RA-102 SECTION

RA-103D, RA-104A, RA-110A SECTION

PRODUCTION CHANGES

Refer to Fig. 1A showing the old or unmodified circuit and Fig. 1B showing the new or modified circuit when making the following changes:

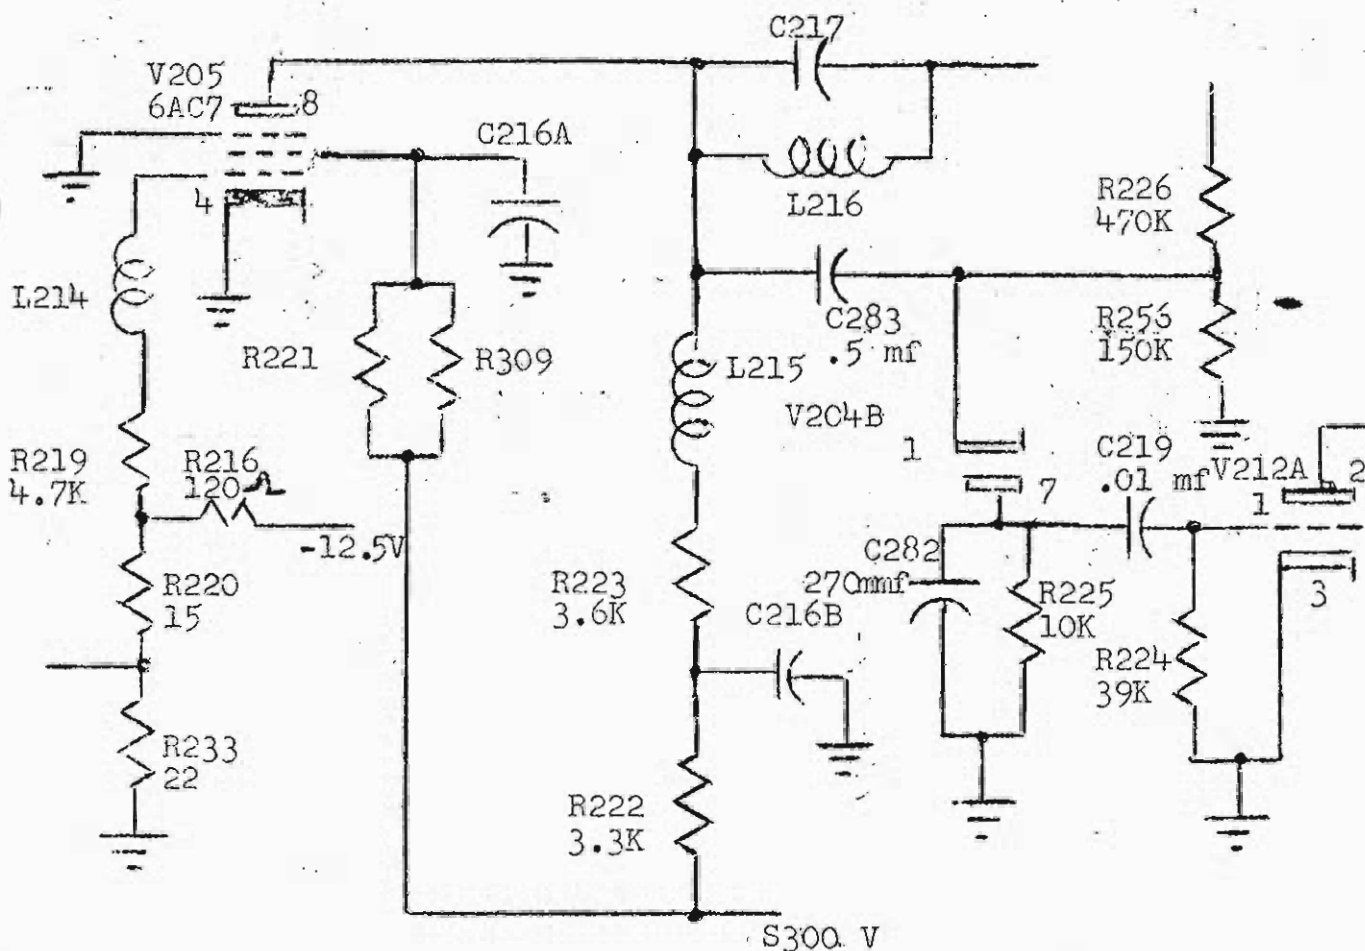
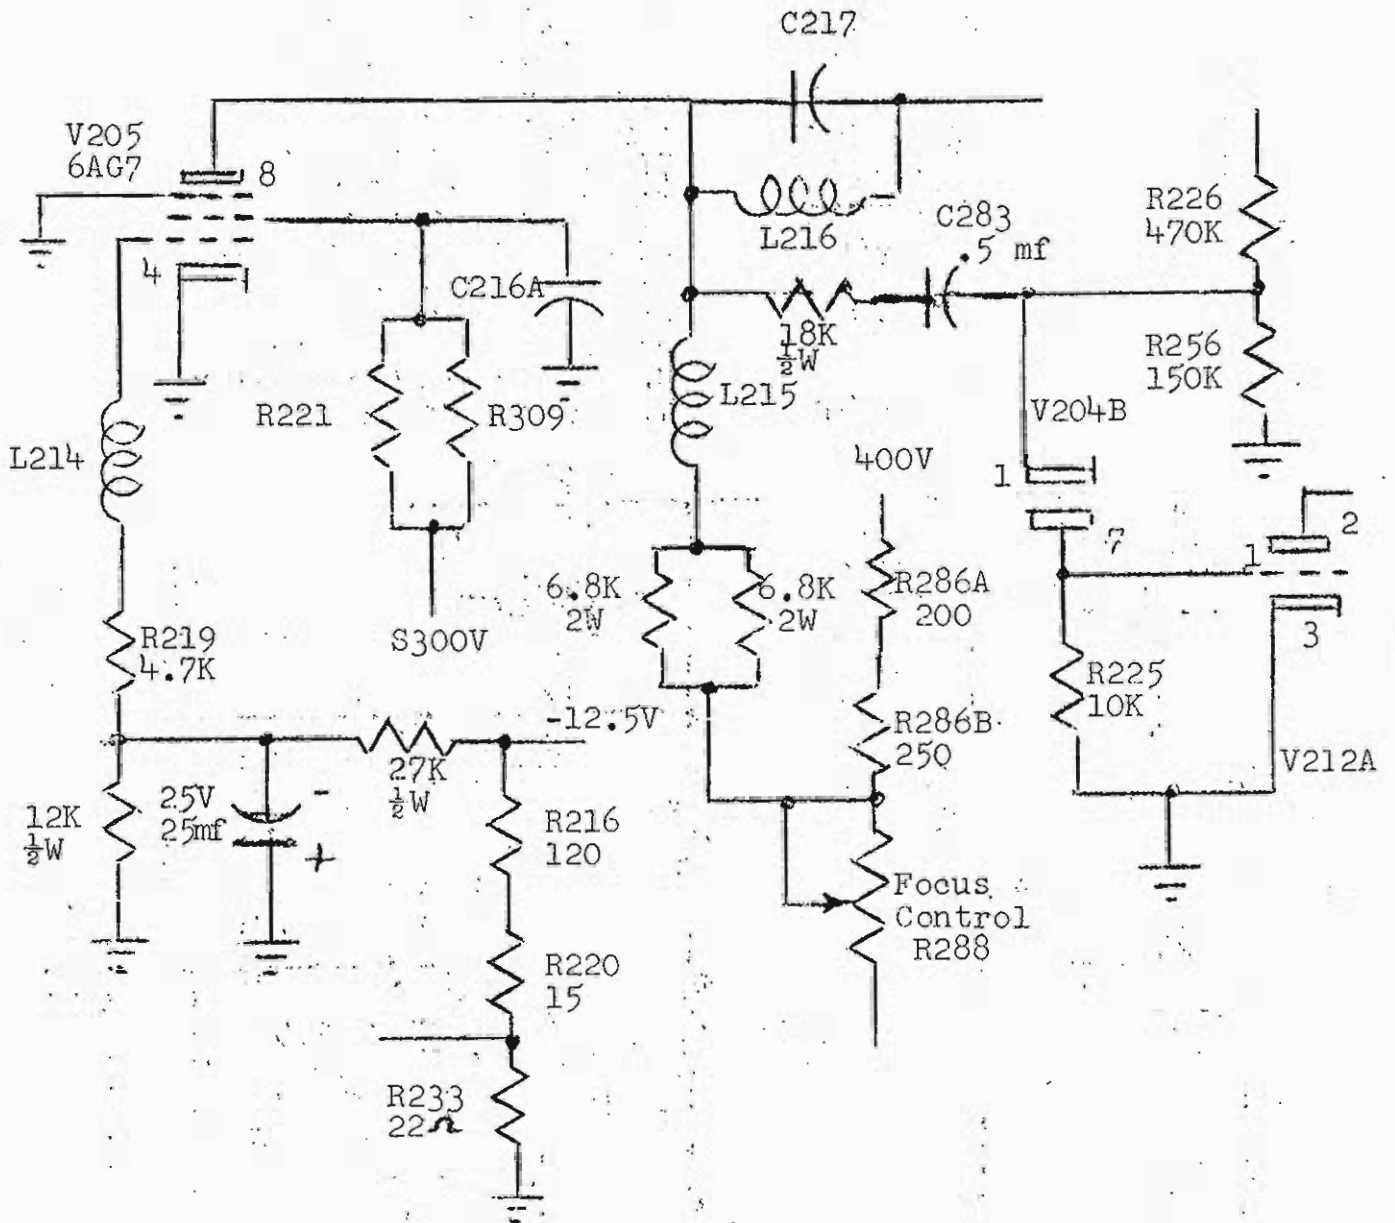
1. Replace V205 the 6AC7 Video amplifier tube with a type 6AG7 tube.
2. Disconnect the low side of R219 (the 4.7K resistor in the grid circuit of V205) from the junction of R216 (120 Ω) and R220 (15 Ω).
3. Connect a 12K $\frac{1}{2}$ watt resistor from the low side of R219 (just disconnected) to ground. Place a 25 mfd 25V capacitor in parallel with this resistor. Be sure to connect the positive side of the capacitor to ground.
4. Add a 27K $\frac{1}{2}$ watt resistor between the junction of R219 (4.7K) and the 25mfd capacitor and 12K resistor added in step 3 and the junction of the -12.5 volt line and R216.

5. Remove R223 (3.6K) (the plate load resistor of the video amplifier) and replace with the two 6.8K 2 watt resistors connected in parallel. Connect one end of this combination to the low end of L215 and run a lead from the other end of this combination to the junction of R288 (the focus control) and R286B (the candohm strip resistor).
6. Remove R222 (3.3K, connected to C216B).
7. Add an 18K $\frac{1}{2}$ watt resistor between the junction of L215, C217 and L216, and capacitor C283.
8. Remove capacitor C282 (connected from pin #7 V204B to ground). Remove capacitor C219 (located between pin #7 of V204B and pin #1 of V212A) and replace with a short lead, using pin #7 terminal lug to which C219 was connected.
9. Remove resistor R224 (located between pin #1 of V212A and ground).

ANTI-FLICKER CIRCUIT

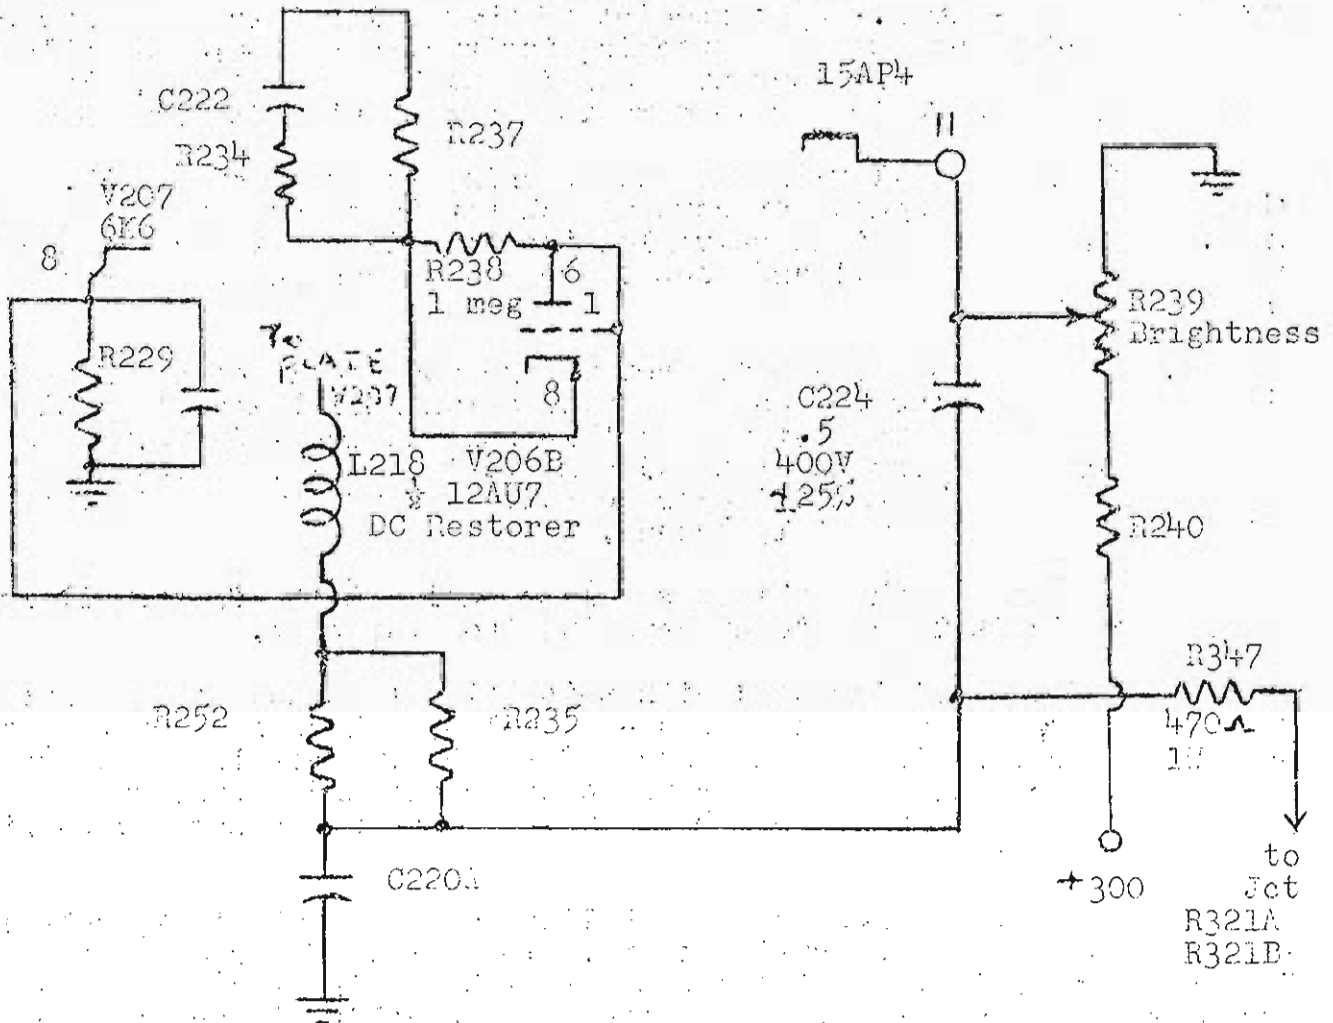
The schematic shown below illustrates changes made in the RA-105, RA-106 main chassis to reduce flicker. The flicker referred to results from periodic line voltage fluctuations such as are produced by reciprocating pumps and like devices. This change is sometimes referred to as an "anti-flicker circuit".

1. Pins #6 and #7 on V206-B the DC restorer tube are removed from ground.
2. Pins #6 and #7 on V206-B are connected together and a lead is run from pin #6 of V206-B to pin #8 of V207, thus returning the DC restorer to the cathode of the third video amplifier instead of ground.
3. Capacitor C224 is changed from .1 200V \pm 25% to .5 400V \pm 25%. The part number of the new capacitor is 03014260.
4. Capacitor C224 is connected between pin #11 of the CRT and the junction of R235 and C220A.
5. Resistor R347 470 ohms 1 W 10% (part #02034730 alternate part #02044730) is connected in series between R232 and R321.

AGC CHANGES

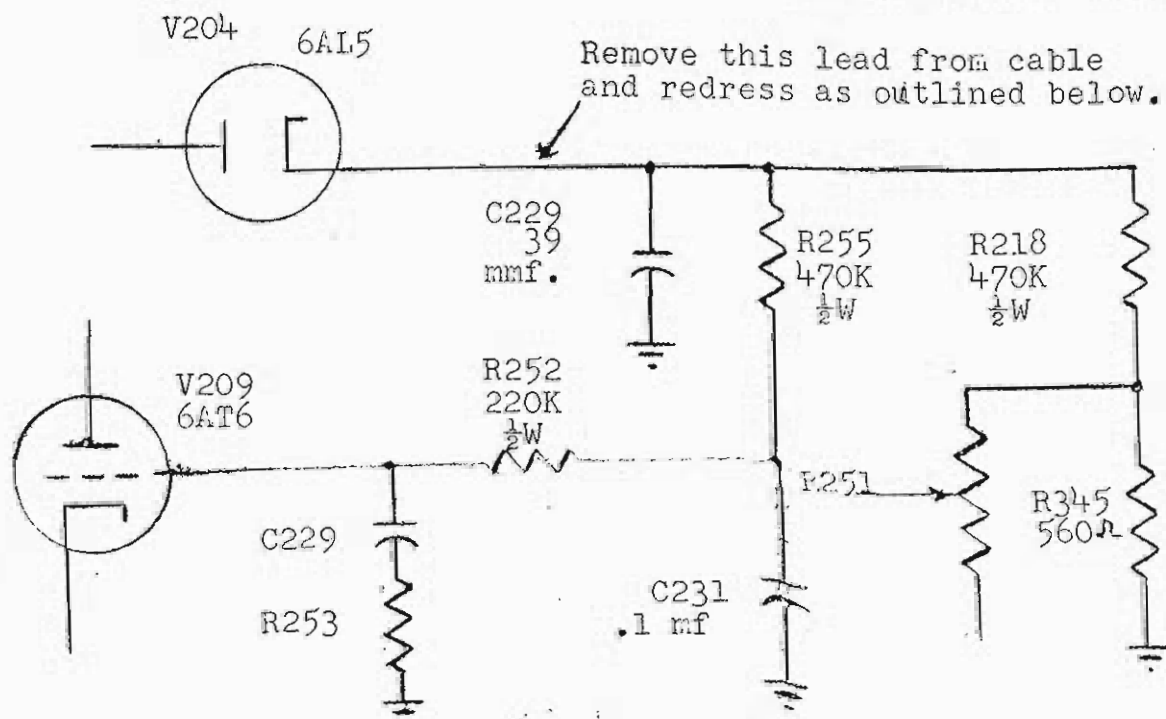
Very humid weather normally encountered in the summer months has been the cause of considerable difficulty with the AGC circuit as used in the early RA-105 Telesets. The condition that is normally encountered was a fading of both picture and sound. When the serviceman checks the set he usually finds that all components are normal and is at a loss to determine the reason for the faulty operation of the receiver. Where this trouble is encountered it is recommended that the following changes in the AGC circuit be made. These changes have been included in production on all of the sets made after March, 1949. The purpose of these changes is to reduce the impedance of the grid circuit of the 6AT6 AGC stage and thus improve the stability of this circuit. The list of changes follow:

A 470K, $\frac{1}{2}$ watt resistor, part number 02032090 between pin #5 of V204 and the junction of R252 and C231 was added.

A 39 mfd. 500 volt ceramic capacitor, part number 03017030 from pin #5 of V204 to ground was added.

Figure 1

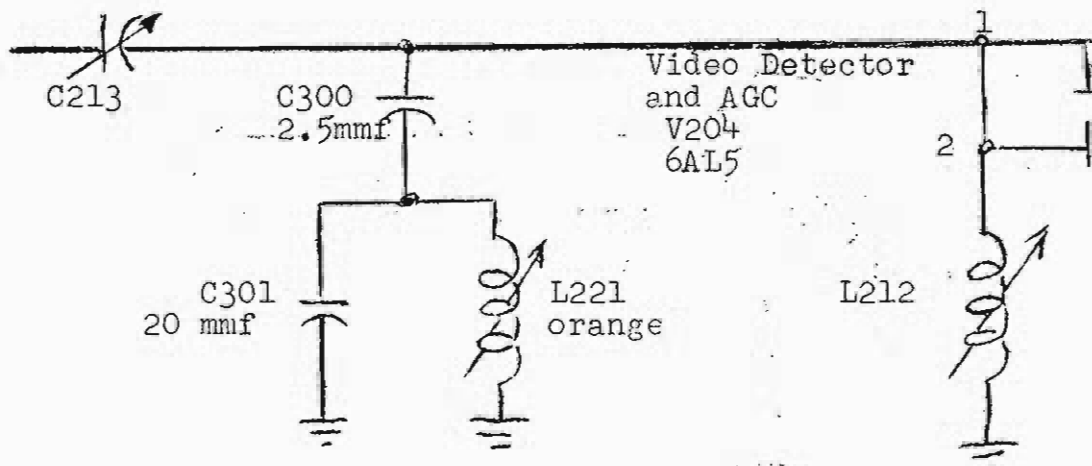
This may be corrected in the field by the addition of a series-parallel resonant trap in the third video IF amplifier as illustrated in Fig. 1. (Note the latest RA-105 and RA-106 Telesets include this trap).

This trap will be tuned to 20.4 mc. This 20.4 mc is obtained when the local oscillator beats with the video carrier of the channel above the desired channel. Consider a location where both channel #5 and channel #6 can be received. With the Teleset tuned to channel #5, 76-82 mc, the local oscillator is tuned to 77.25 mc (video carrier of channel #5) plus 26.4 mc or 103.65 mc. The local oscillator signal also beats with the video carrier of channel #6 (83.25 mc) and produces a frequency equal to the difference between 103.65 mc and 83.25 mc which is 20.4 mc.

Figure 2

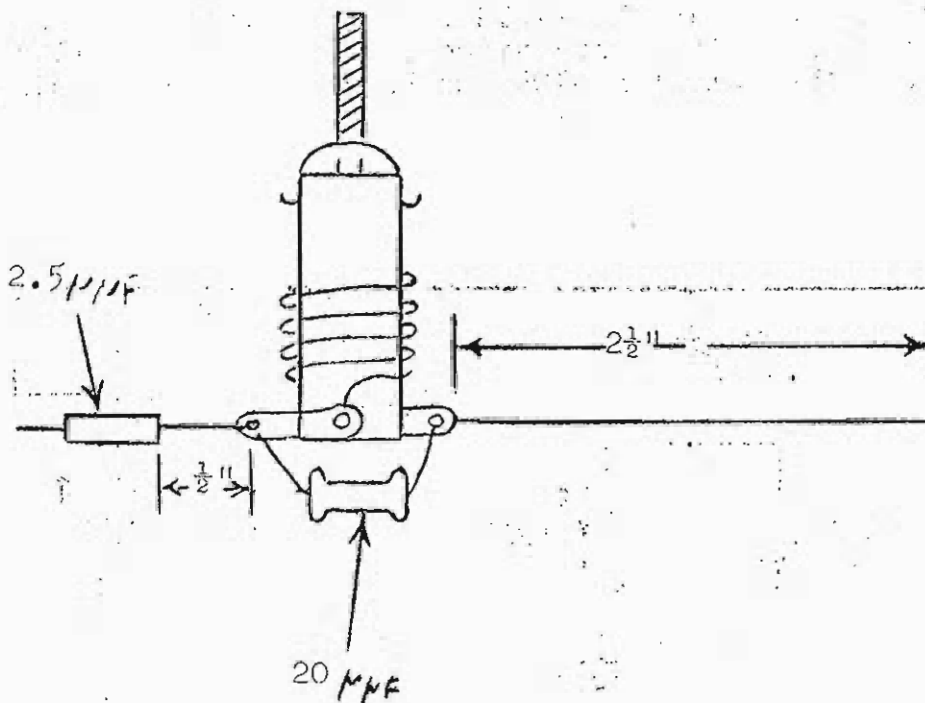
Connect the 2.5 uuf capacitor to the lug to which the end of the winding closest the lug is soldered, leaving $\frac{1}{2}$ " of wire between the body of the capacitor and the lug.

Connect a $2\frac{1}{2}$ " length of #18 bare-tinned copper wire to the other lug of the inductor. Connect the 20 uuf capacitor across both of the lugs of the inductor. See Fig. 2.

Figure 3

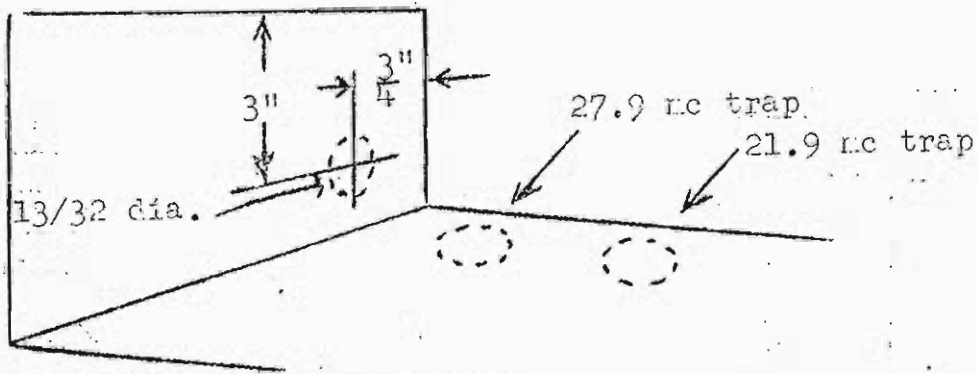
Carefully enlarge the "keyhole", to $\frac{13}{32}$ diameter, in the video IF amplifier shield plate using a Parker-Kalon Metal Punch X. See Fig. 3.

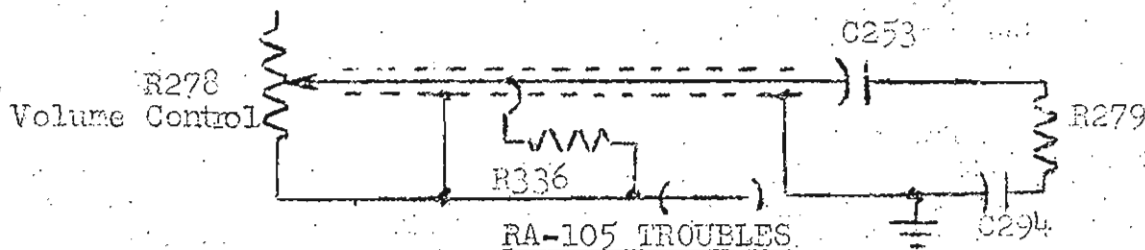
The schematic of the Main Chassis (dated Nov. 15, 1948) should be corrected as shown in the following sketch:

(The error is in the volume control circuit, where R336 is shown shorted out and the "hot" wire of the shielded lead is shown grounded. The sketch shows the correct connections).

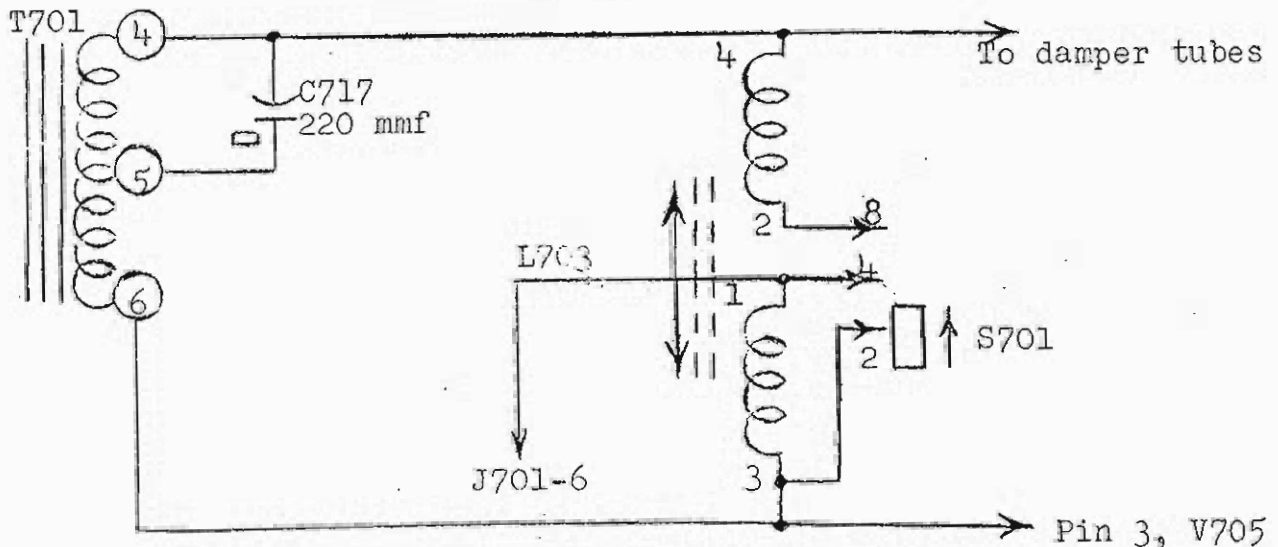
The following circuit change has been made since the schematic diagram for the RA-108A power supply was issued.

The size selector switch (S701), the horizontal size inductor and circuit were changed as shown in the following sketch:

In this new circuit, please note that L704, part #21004763 is no longer used. The description and part numbers of the new parts follow:

The change was made in order to reduce excessive temperatures in the horizontal deflection transformer T701.
